VA Hot Springs DOM Renovation Building 8  
Hot Springs, South Dakota

**ADDENDUM NO.:** 01**DATE ISSUED:** 08-22-2025**BIDS DUE:** 09-03-2025**ARCHITECT'S PROJECT NO:** 211921

**Date:** 8/22/2025**Project:** Dom Renovation for Semiprivate Rooms**To:** All Plan Holders**Project #:** VA# 568-20-208, WPE# BR21039**From:** David Dowling/Michael Heinrich, Mike Sigman**Project Location:** Hot Springs, South Dakota**Addendum Number:** #001

Drawing Number  
G1100

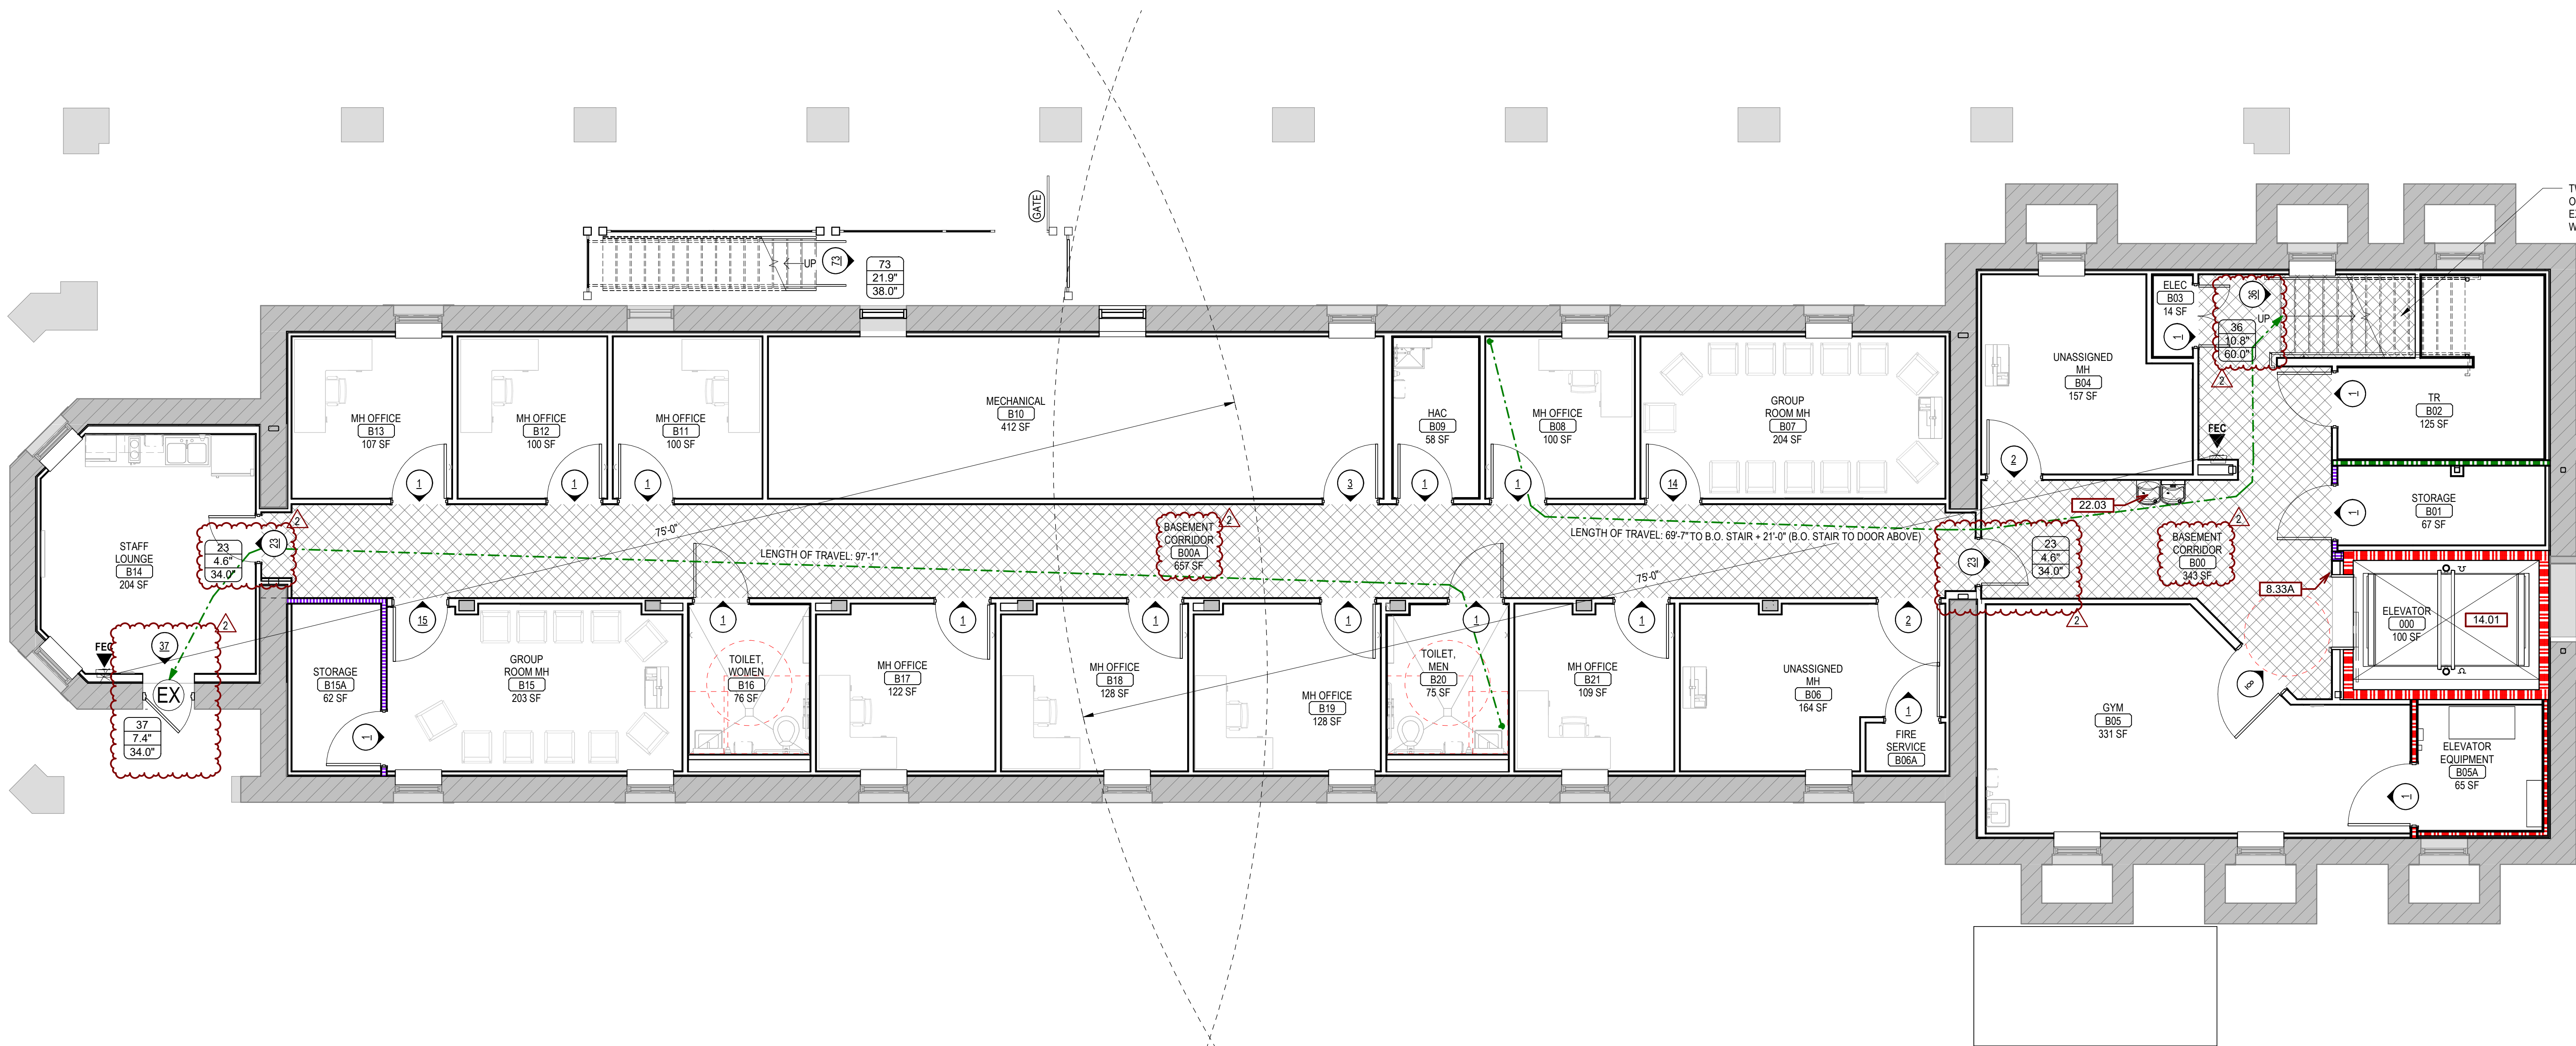
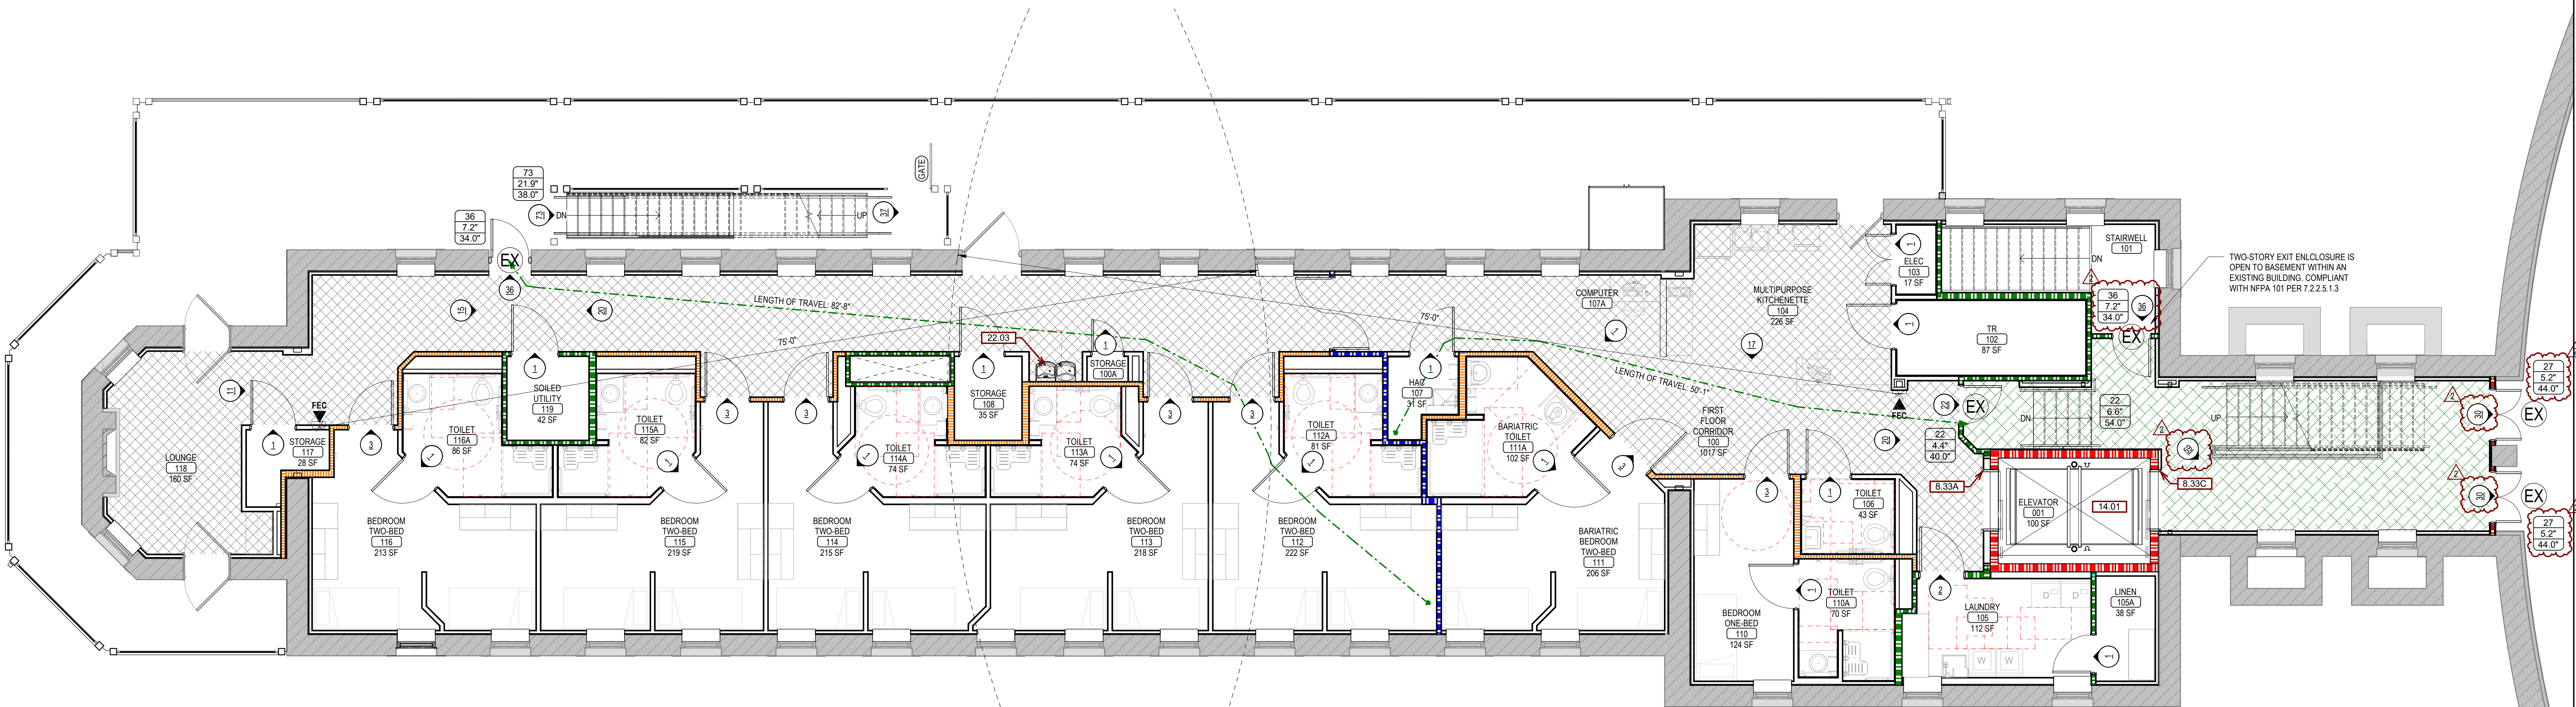
- ITEM NO: 1: GI100 – Life Safety Plan – Basement
- a) Added door in basement corridor.
  - b) Split basement corridor into two separate rooms and adjusted naming/numbering accordingly.

- c) Updated background to show a new exterior door in the basement.
  - d) Updated occupant egress loads per change to basement corridor(s).
- ITEM NO: 2: GI101 – Life Safety Plan – 1<sup>st</sup> Floor

**Drawing Number**  
AD100

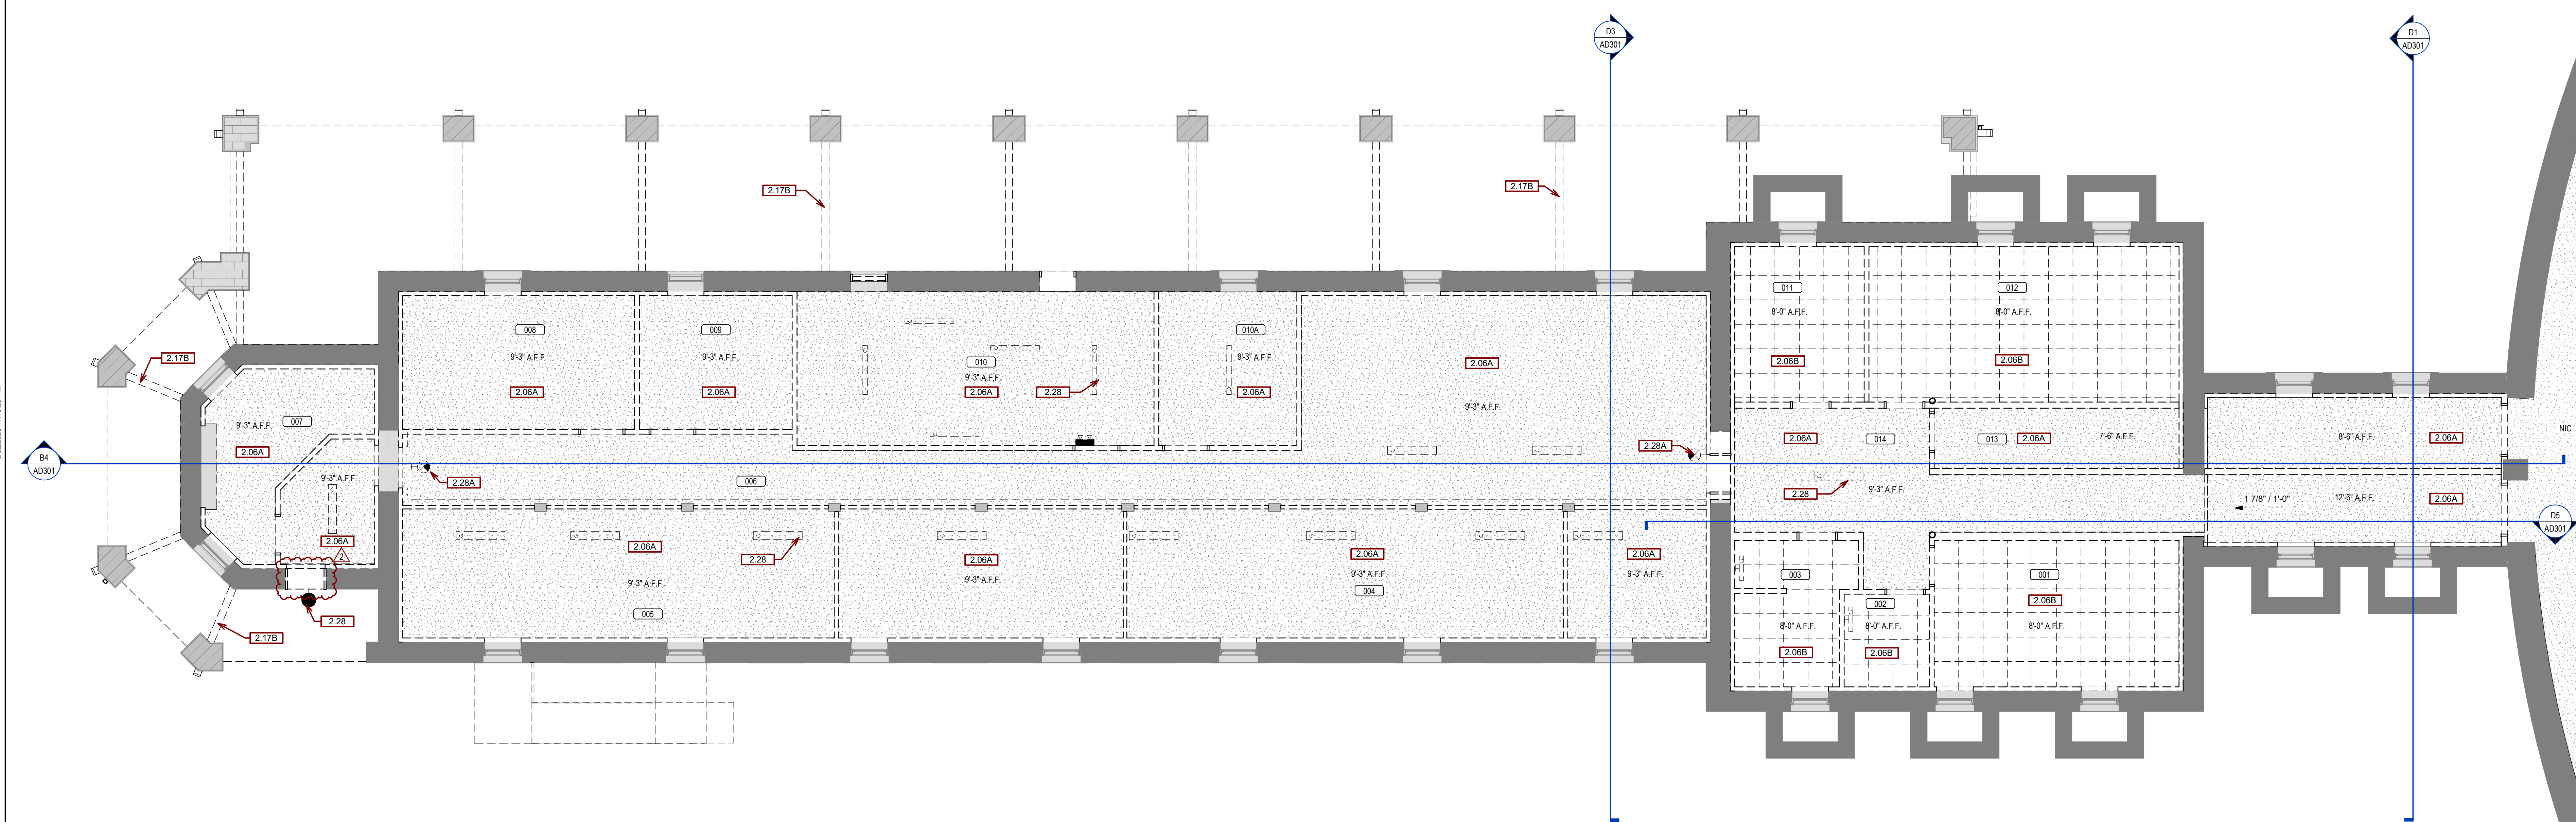
- a) Added missing keynote tags to plan (2.91)
- ITEM NO: 6: AD100 – Demolition Plan – Basement
- a) Updated background to show the full removal of the existing exterior door in the basement.

- b) Added keynote to existing exterior door in the basement (2.03).

Drawing Number  
AE110

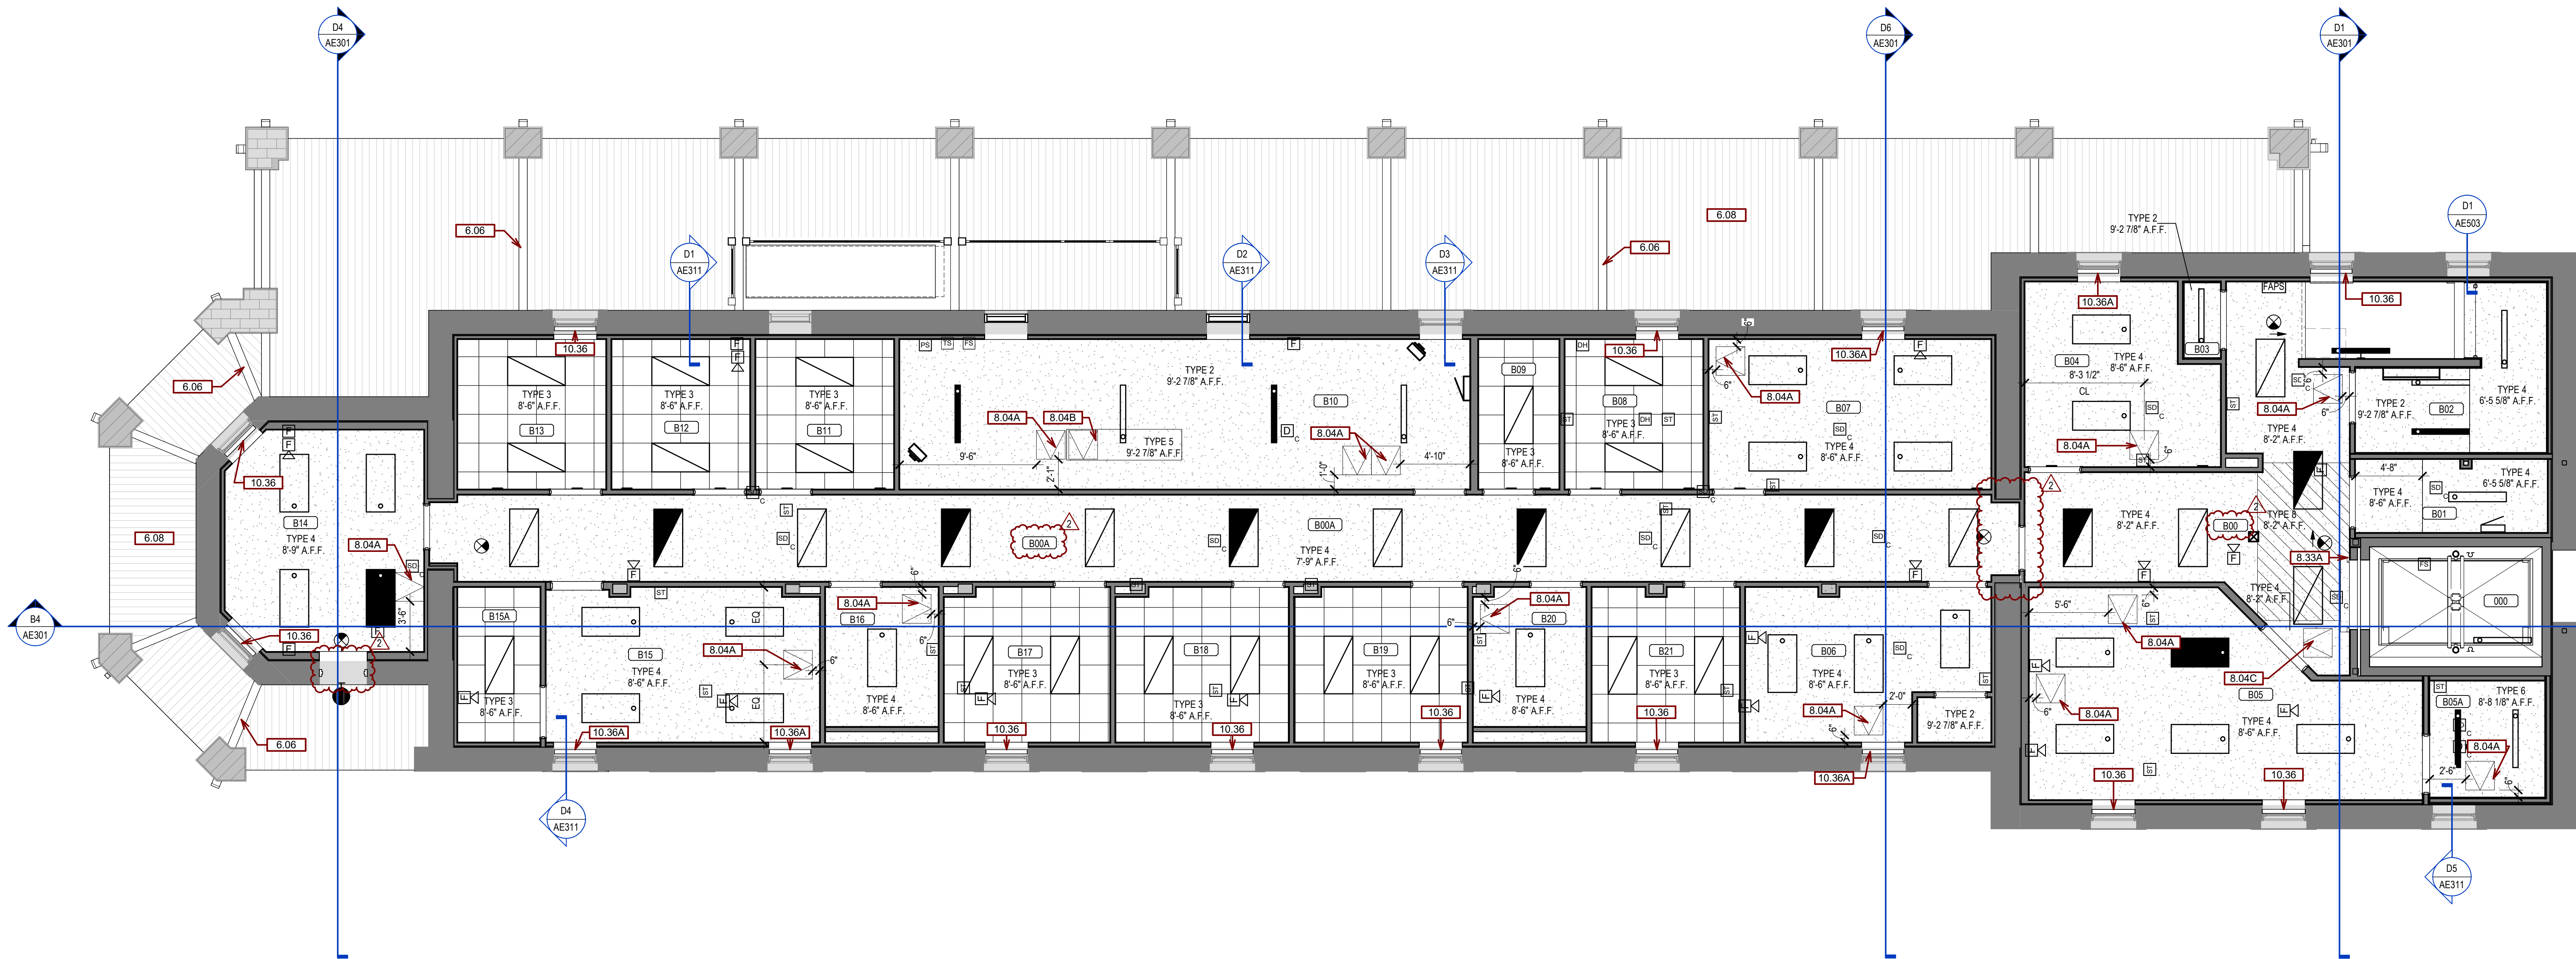
ITEM NO: 10: AE110 – Reflected Ceiling Plan – Basement

- a) Updated background to show a new exterior door in the basement.
- b) Updated background to show a new corridor door in the basement.
- c) Split basement corridor into two separate rooms and adjusted naming/numbering accordingly.
